Correction of Peer Delay Measurement for Frequency Offset of Responder Relative to Requestor Revision 1

IEEE 802.1 AVB TG
2008.09.15

Timing of Pdelay Message Send and Receive Events

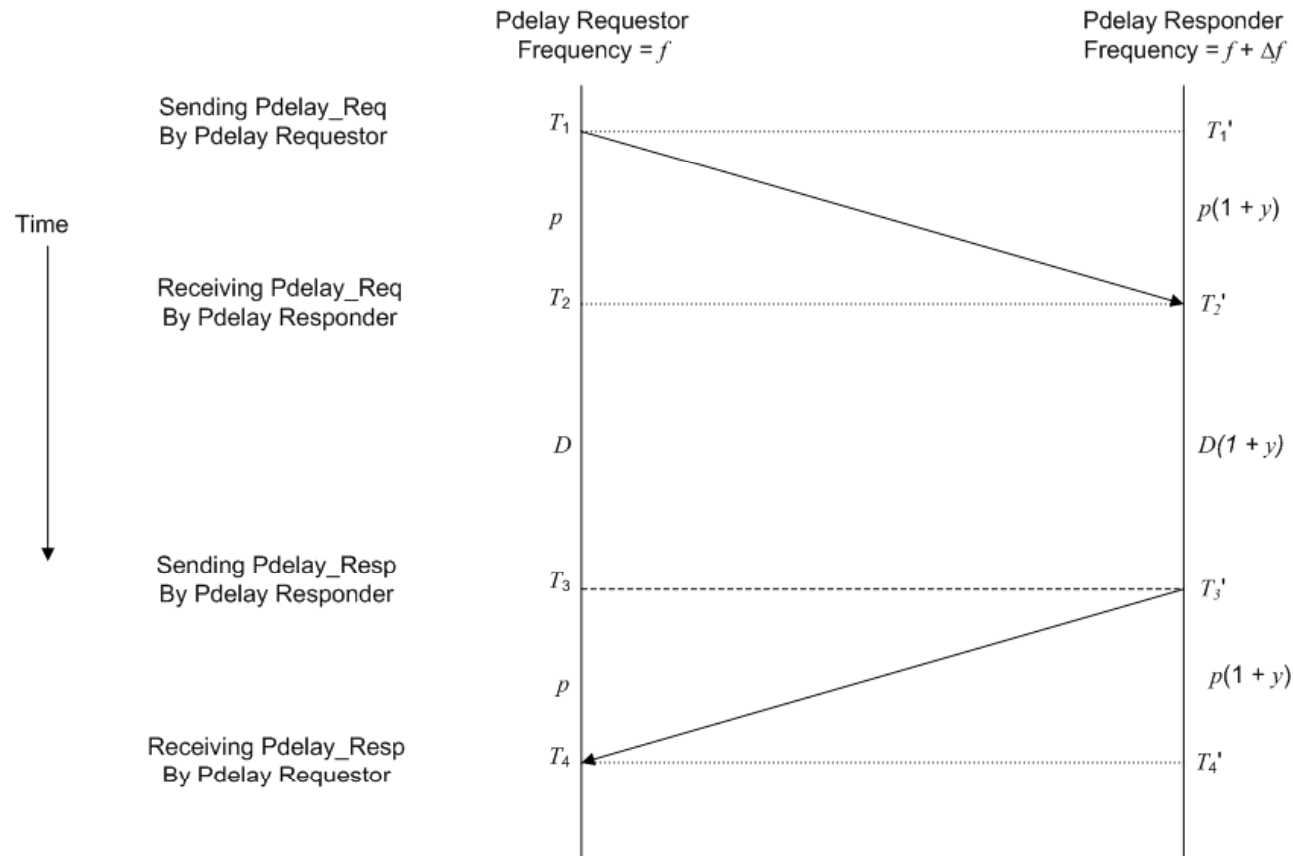
- ❑ Comment #24 of the initial 802.1AS D4.0 comments indicates that the multiplication by neighborRateRatio r should be a division in Eq. (11-2), given that r is defined as the ratio of the rate of the responder to that of the requester.
- ❑ Eq. (11-2) in D4.0 is:

- ❑ According to comment #24, this equation should read

- ❑ The purpose of this presentation is to derive the correct form for this equation
 - The form given in the proposed resolution of comment #24 (i.e., with the division by r) is a very good approximation
 - The presentation derives an alternative good approximation, and also an exact for

- The final equation on the previous slide is the desired result
 - With the notation of the figure of slide 3, the primed quantities denote the time relative to the Pdelay responder

□ On links where r_2 is known (it is the cumulative rate ratio carried in Follow_Up, the exact result can be used. On other links (i.e., those not currently part of the synchronization spanning tree), one of the approximate forms can be used
